Ref: Planning Application DM/23/0550
Proposed Loft Conversion, Dormer Roof Extension To Fen Place
Bungalow, East Street, Turners Hill RH10 4QA

Plan A

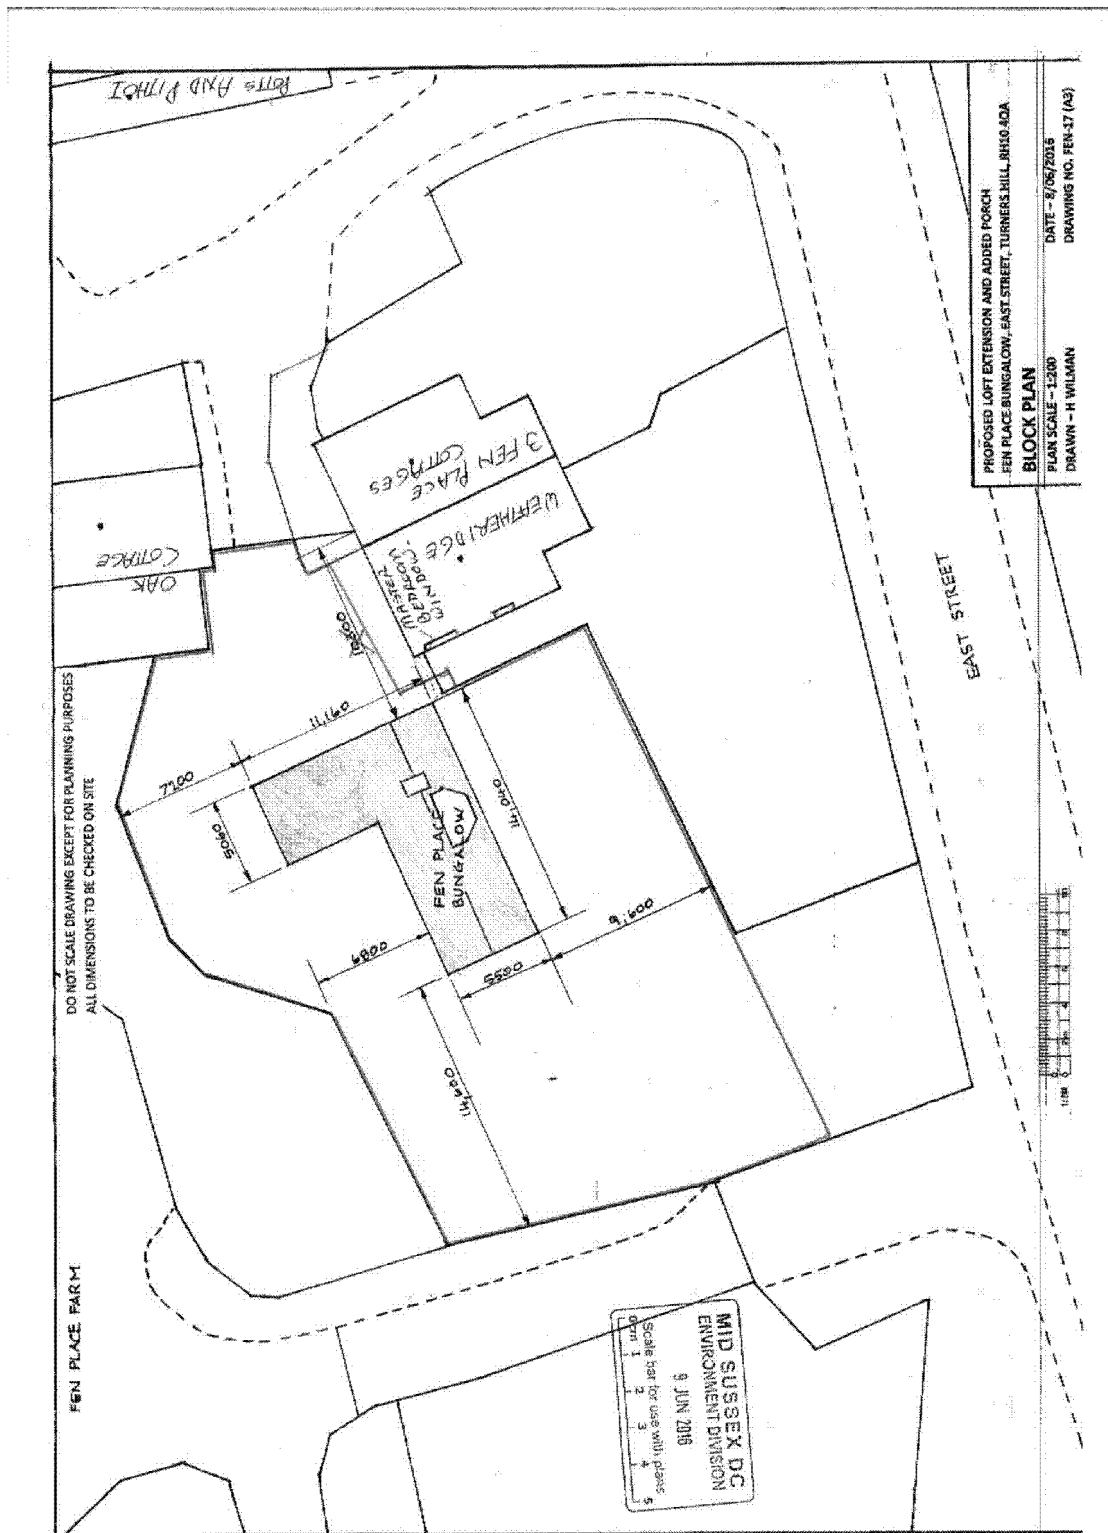
I do want to specifically point out that the land ownership of Fen Place Bungalow shown on Location Plan and Site Block Plan and Block Plan Drawing No WPD5922/A/02 is incorrect. The actual property boundaries are shown in red on attached Plan A.
